**6.4** 276-284 INGLES STREET, PORT MELBOURNE

**PREPARED BY:** SIMON GUTTERIDGE, PLANNING TEAM LEADER FISHERMANS BEND

- 1.1 To provide a Council position for the Fishermans Bend Standing Advisory Committee on a request to the Minister for Planning to prepare, adopt and approve an Amendment to the Planning Scheme under Section 20(4) of the Planning and Environment Act for 276-284 Ingles Street, Port Melbourne.

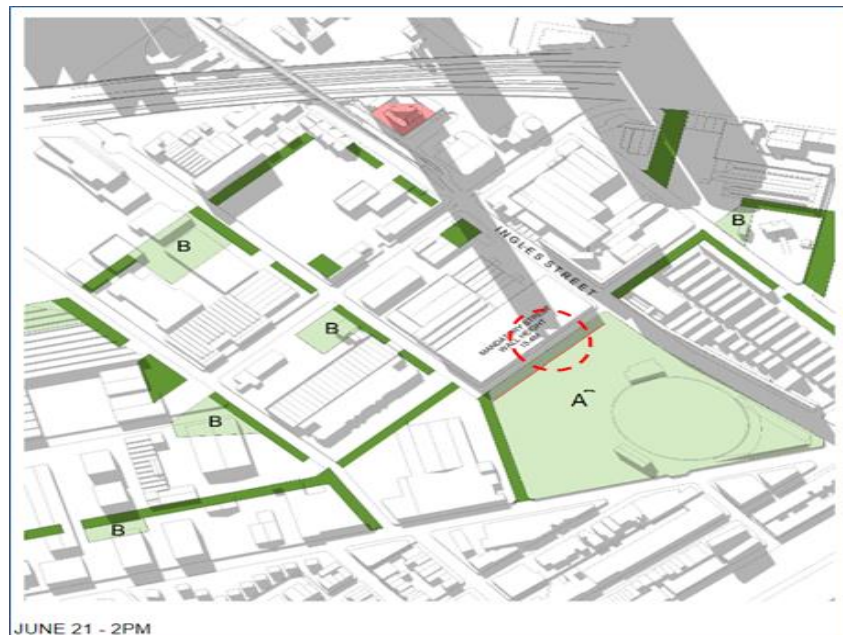
Pre-application plans for the subject site proposed a maximum 87 levels / 309.1m (311m AHD) tower. DELWP, Council and other agencies raised concerns that proposal would overshadow existing and proposed new

The application plans reduced the maximum height to 56 levels / 197.1m (199m AHD) to reduce shadow impacts. Shadow plans show the proposal would meet the overshadowing control and **would not** cast any additional shadow above the shadows cast by hypothetical buildings built to the Maximum street wall height and existing buildings over the above areas of proposed new public open space at the specified times.

Notwithstanding the above, in response to Statutory Planning and City Design Concerns about the limited difference in height of the three elements of the tower, Councils City Strategy Team noted some additional height might be possible without compromising the mandatory overshadowing requirements.

It is recommended that the top of the tower be amended to provide greater variation in height of the three elements of the tower, and that this may include an increase in height subject to still meeting the overshadowing controls for North Port Oval and the 3 new parks shown on Map 4 of DDO32.

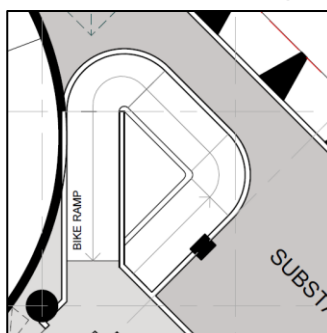
- Inadequate car parking space clearance from columns and walls;
- DDA parking space design and dimensions revised to be fully compliant;

**Fig** – Location of 12 car spaces subject to agreement.

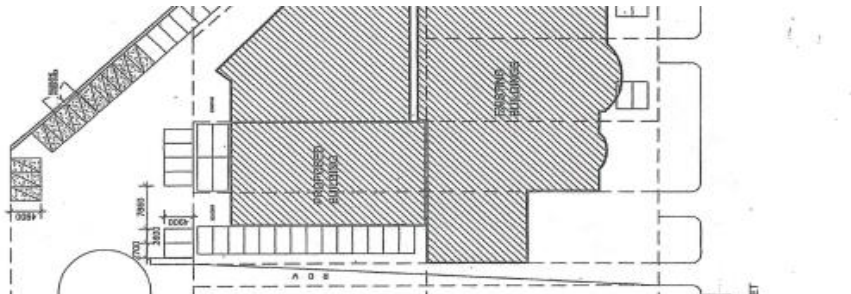
- 13.6 The car park and the 12 car spaces subject to the agreement are in part in the alignment of the future 12m (w) road proposed by the Framework and Planning Scheme and shown on the streetscape and landscape plans for the proposal.
- 13.7 The agreement concerning the car park and the 12 car spaces would need to be resolved before the new road from Anderson Street to Ingles Street could be constructed.
